SERVICE INFORMATION LETTER

Subject: Shaft External Spline Slightly Oversize Possibly Affecting Installation

Service Information Letter No: 130123-001
 Page 1 of 4

Figure 1, Inner Shaft Showing Oversize Spline Area

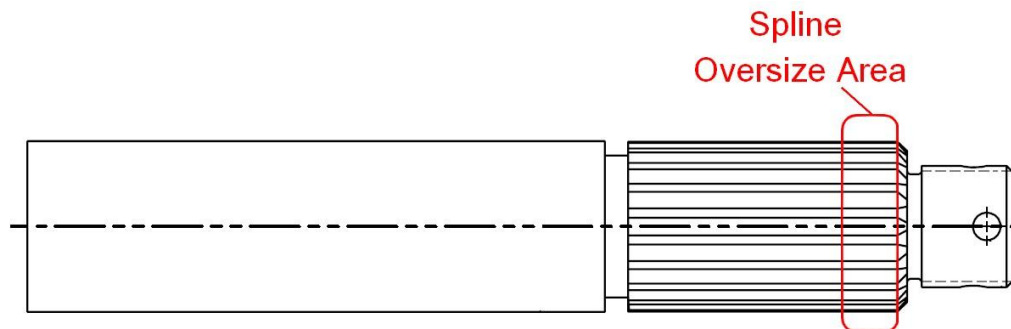
An unknown quantity of the Wencor Inner Shaft's PN 65B13152-3WE were manufactured with a slightly oversize external spline (approx. .0004") as measured on the pitch diameter over pins. The oversize condition was found to be near the end of the spline area as shown in Figure 1. This condition may affect or prevent the installation of the Shaft into the NHA if the internal spline on the mating part is at its minimum size creating a tight fit condition.

However, it is also possible that this condition will not ever be noticed during an installation because of the size condition of the mating part.

The manufacturing process of the Shaft did not account for the possibility of spline taper, which appears to be the cause for the out of tolerance condition. When the Shaft spline was inspected, the end of the spline area was not measured, but only the middle area was measured which was found to be within tolerance. The end of the spline area, which was slightly out of tolerance was not properly inspected, which allowed the out of tolerance Shafts to be accepted, sold to customers and put into service.

Wencor has taken appropriate corrective action to ensure all Inner Shafts manufactured after August 2012 meet the size and process requirements as defined on the Wencor drawing.

Figure 2, Inner Shaft in Passenger Door Handle Mechanism

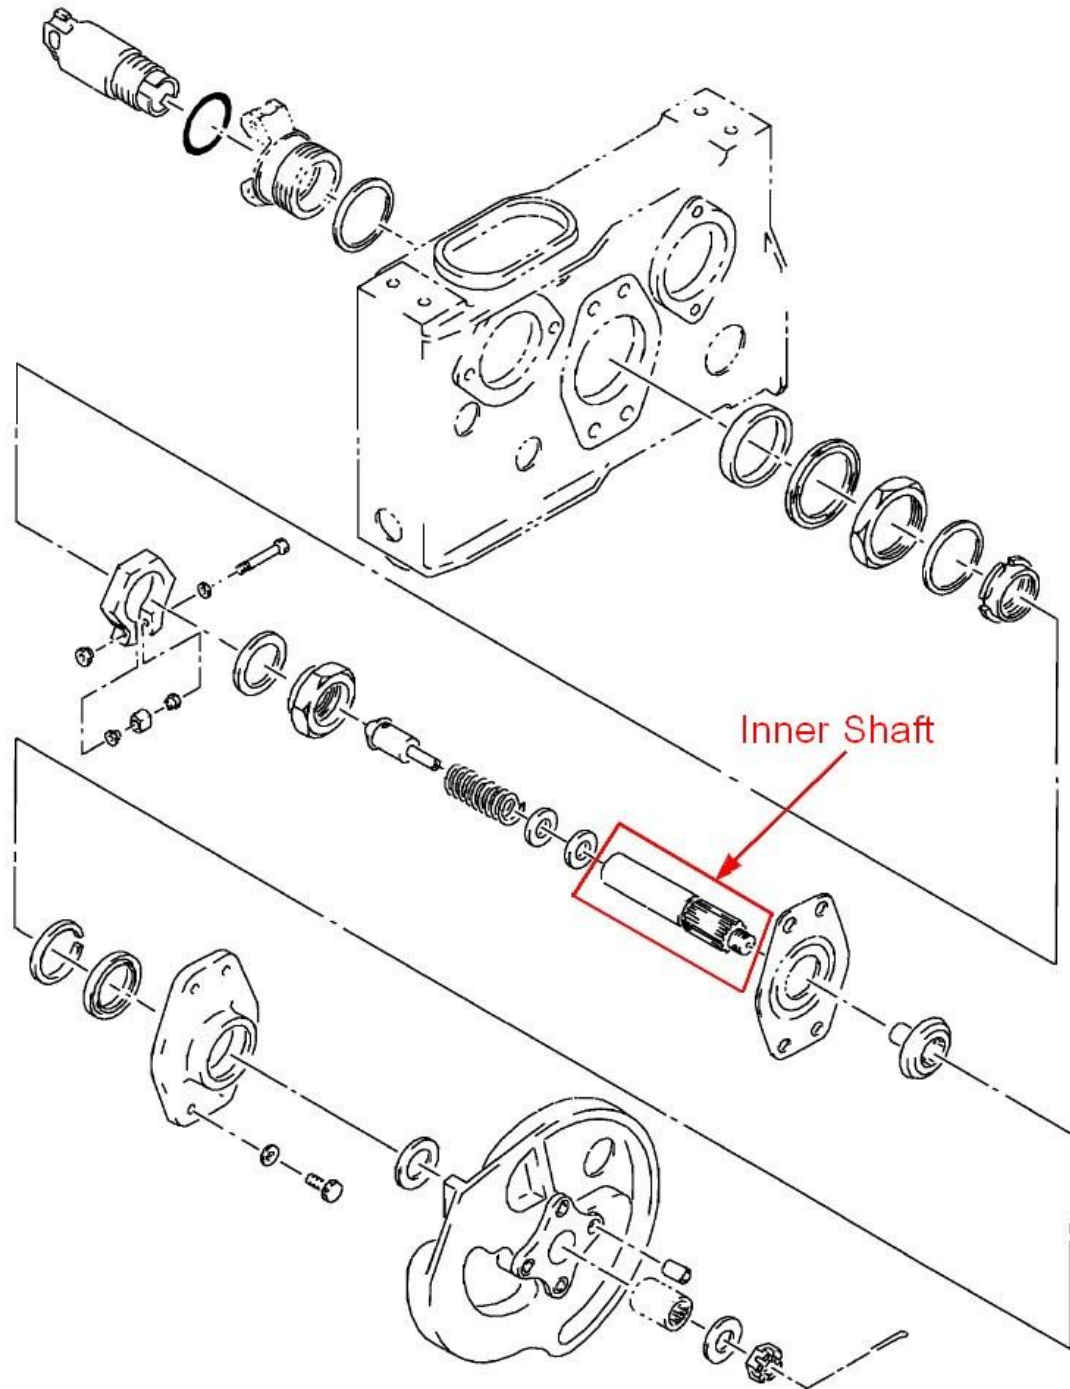
To confirm acceptable usage of the Wencor Inner Shaft, the user shall perform a fit check with the NHA. If the Wencor Inner Shaft can be installed in a normal manner according to the CMM (see Figure 2), the Wencor Inner Shaft can be put into service without any concerns.

If the user suspects an out of tolerance condition on the spline or has trouble installing the Wencor Inner Shaft into the NHA, the Shaft should be returned to Wencor for replacement.
